# Access Compliance Report

## Public Rights-of-Way

### (Curb Ramps)

Intersection ID: 52476	Main Street: WHITEHALL_EXECUTIVE_CENTER_DR	Cross Street: N/A	Location: SE
ADA ID: C24E557A24CA	Ramp Type: Perp	Initial Pass/Fail: Fail	Overall Compliance: No
Severity Score: 1.25			
Codes/Mitigation Info/Possible Solution		Field Measurements/Component Compliance

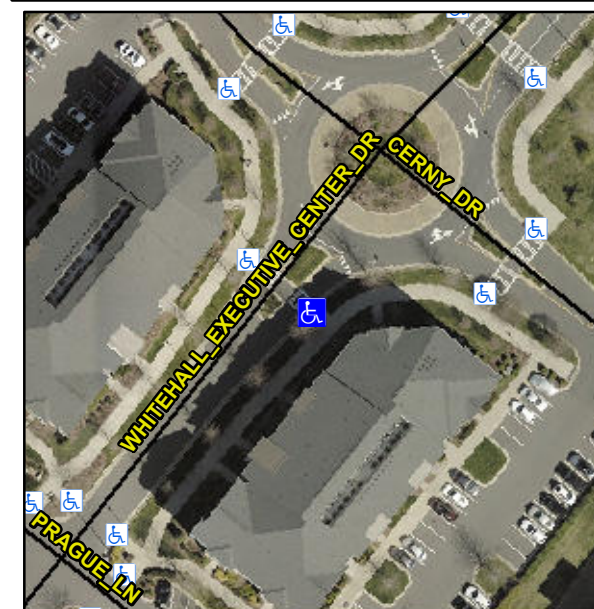
**Not Found, R304.5.3**

Compliance	Description	Data	Compliance	Description	Data
N/A	Ramp Length (in)	94.0	Yes	Ramp Slope (%)	6.7
Yes	Ramp Width (in)	95.0	No	Ramp XSlope (%)	2.6
N/A	Flare Type LT	N/A	N/A	Flare Type RT	N/A
N/A	Flare Slope LT (%)	N/A	N/A	Flare Slope RT (%)	N/A
N/A	Flare Traversable LT?	N/A	N/A	Flare Traversable RT?	N/A
N/A	Landing Length (in)	N/A	N/A	DWS Provided?	N/A
N/A	Landing Width (in)	N/A	N/A	DWS Contrast?	N/A
N/A	Landing Slope (%)	N/A	N/A	DWS Length (in)	N/A
N/A	Landing X Slope (%)	N/A	N/A	DWS Full Width?	N/A
N/A	Landing Curb? (Y/N)	N/A	N/A	DWS Offset (in)	N/A
N/A	Shared Landing?	N/A			
N/A	Gutter Ponding?	N/A	N/A	Gutter Slope (%)	N/A
N/A	Gutter Lip Ht (in)	N/A	N/A	Gutter X Slope (%)	N/A
N/A	Painted X Walk1?	Yes	N/A	Painted X Walk2?	N/A
	X Walk 1 Direction	To NW		X Walk 2 Direction	N/A
N/A	X Walk 1 Width (in)	89.0	N/A	X Walk 2 Width (in)	N/A
	X Walk 1 Slope (%)	2.5		X Walk 2 Slope (%)	N/A
	X Walk 1 X Slope (%)	0.3		X Walk 2 X Slope (%)	N/A

**Remove & Replace Entire Ramp.**
